Dresden Nuclear Power Station, Units 2 and 3  
Facility Operating License Nos. DPR-19 and DPR-25  
NRC Docket Nos. 50-237 and 50-249

**Subject:** Response to Request for Additional Information – License Renewal  
Environmental Report for Dresden Nuclear Power Station, Units 2 and 3

**Attachment 1**

**RAI Responses Related to Severe Accident Mitigation Alternatives**

Figure 3-1  
 Typical Dresden Level 2 Containment Event Tree

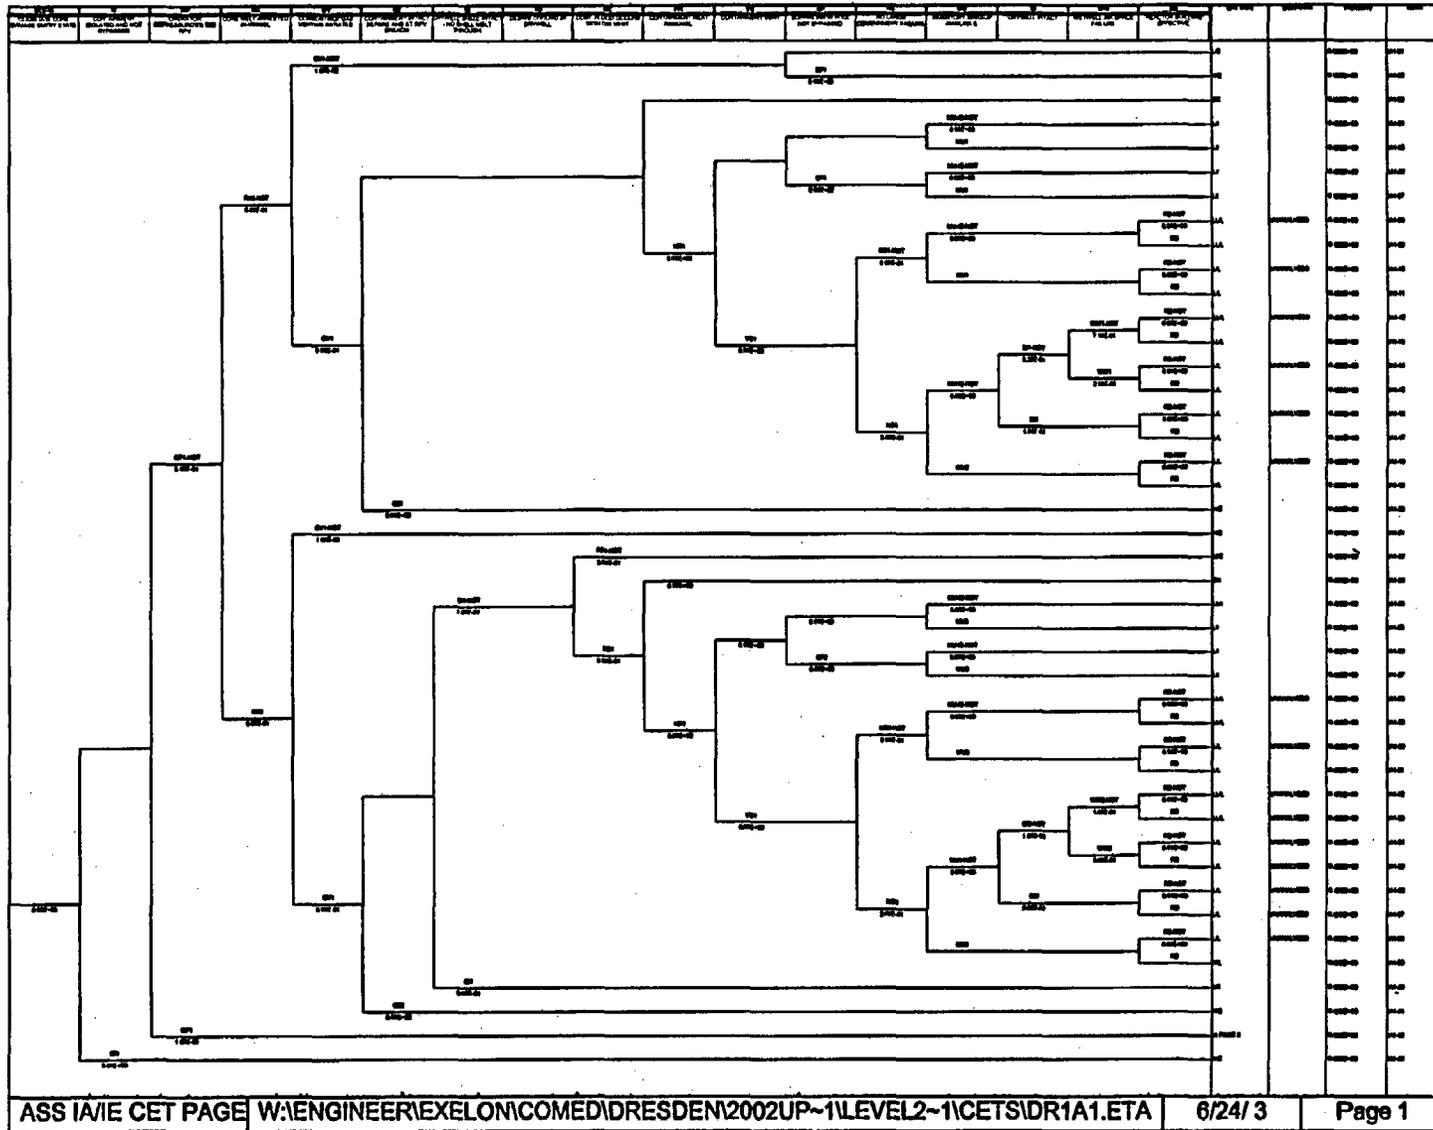
*"[Provide] each release (consequence) category used in the Level 3 analysis (as listed in Column 1 of Table 4-5), the specific source terms used to represent each release category, and a containment matrix describing the mapping of Level 1 results (plant damage state frequencies) into the various release categories."*

The CET calculation for each cutset uses Boolean logic and fault tree models to process the incoming Level 1 cutsets to ensure that the resulting Radionuclide release frequencies properly reflect the impact on release magnitude and timing of the containment and containment mitigation systems. A typical CET (for Accident Class 1A) is provided in Figure 3-1.

In summary, the Level 1 end states do not translate directly into release categories. Each Level 1 accident sequence (all of the cutsets) is transferred into the appropriate CET. The CET is then used to determine the resulting frequency for each radionuclide release end state from each incoming cutset. This is typical of a full Level 2 for a binned fault tree model. This approach does not involve a matrix that relates Level 1 sequences directly to Radionuclide end states.
